RWYs 03. 08. 12. 21

(RNAV SID) - ICAO

NAT1A/1B/1D, SUVAS1G

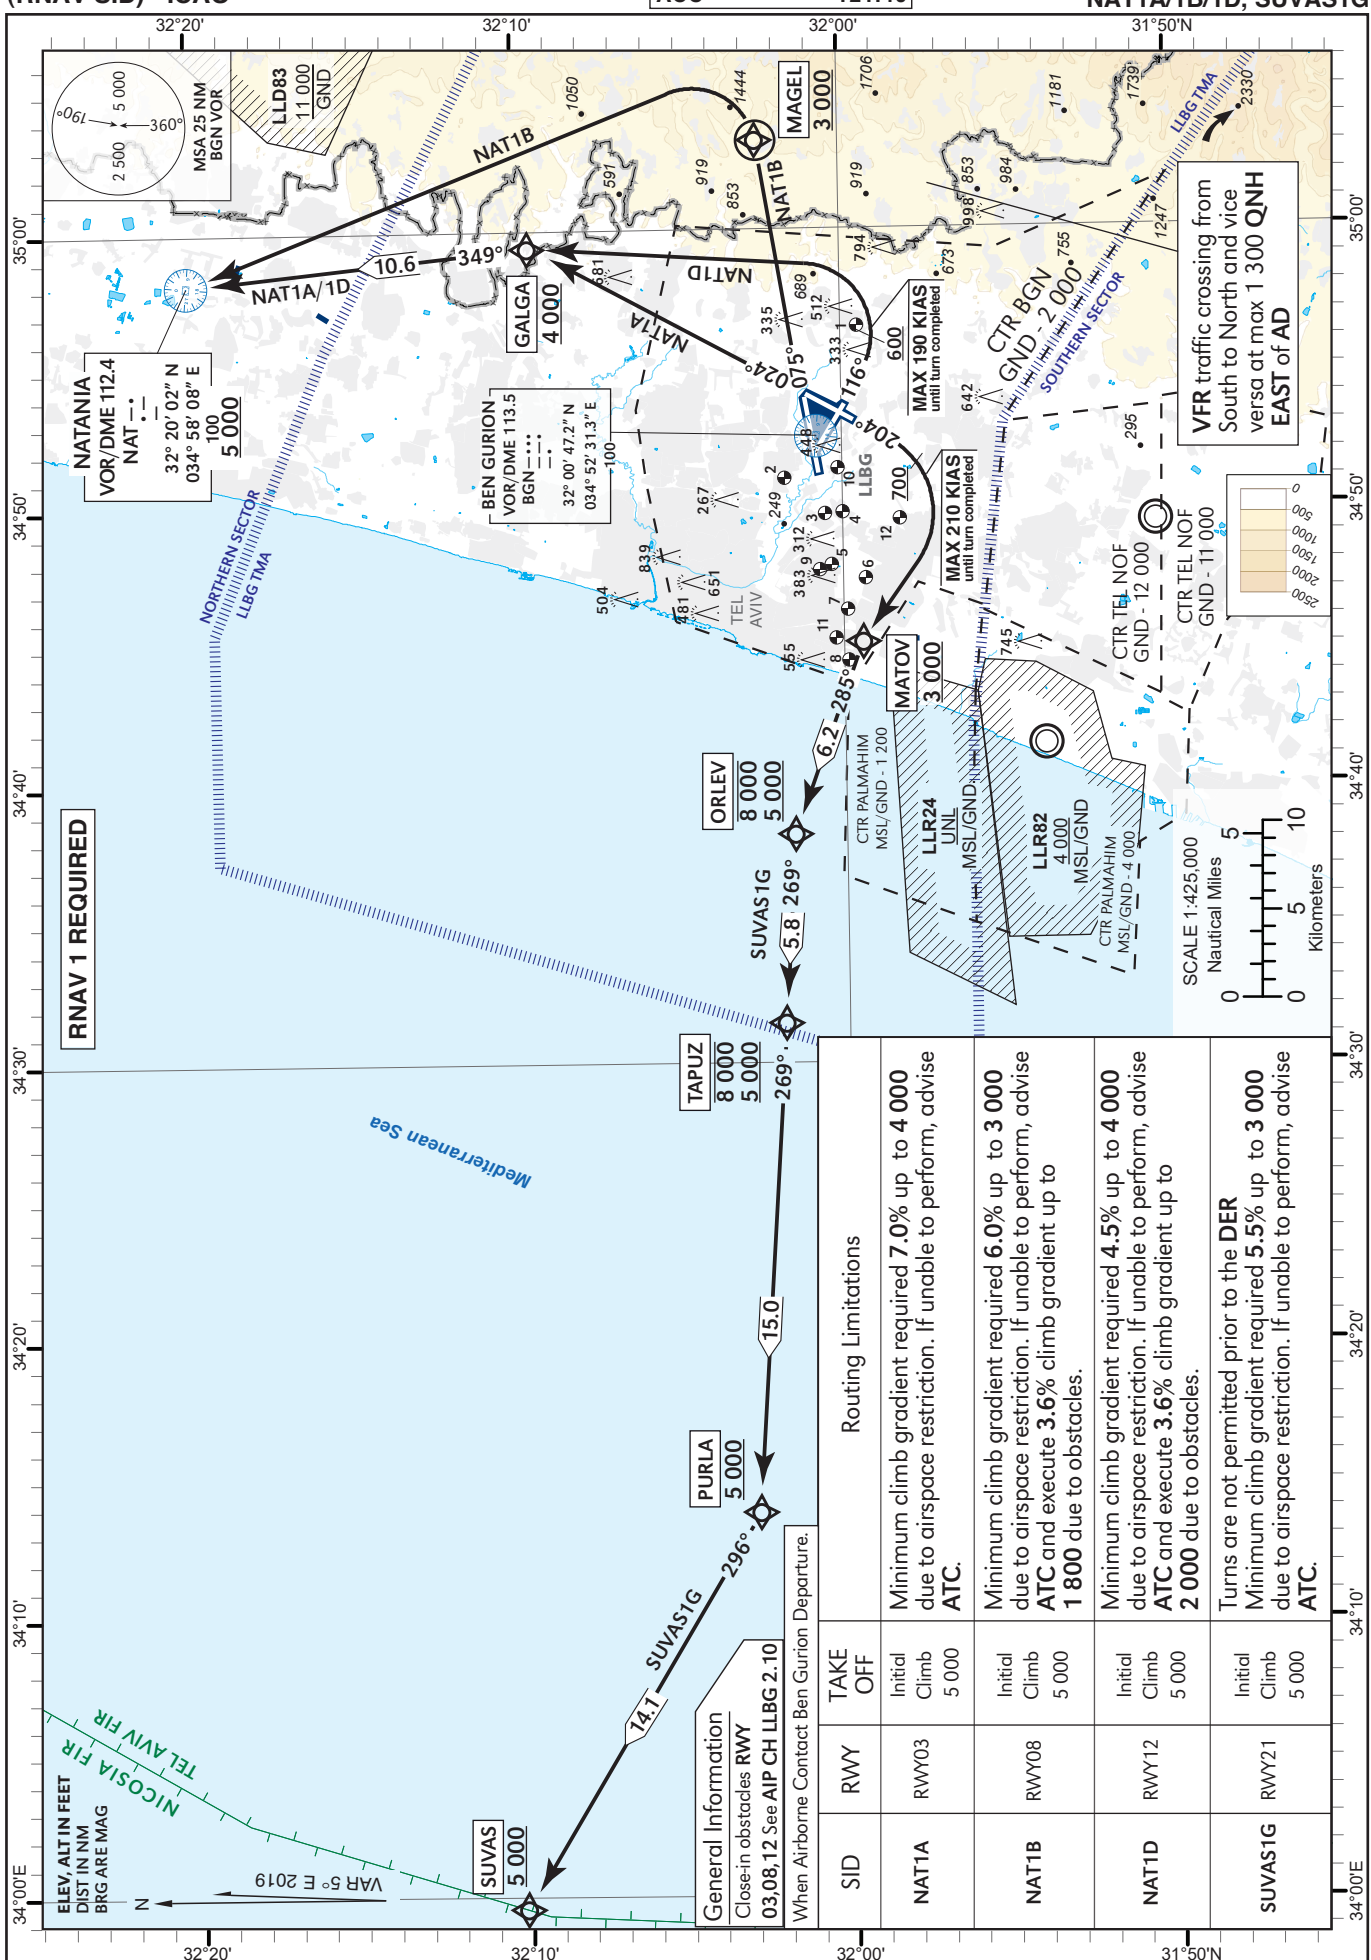
CHANGES: General Information Added, Routing Limitation Table Updated, ALT at TAPUZ Updated, Speed Restriction at MAGEI Withdrawn, Coding Table.
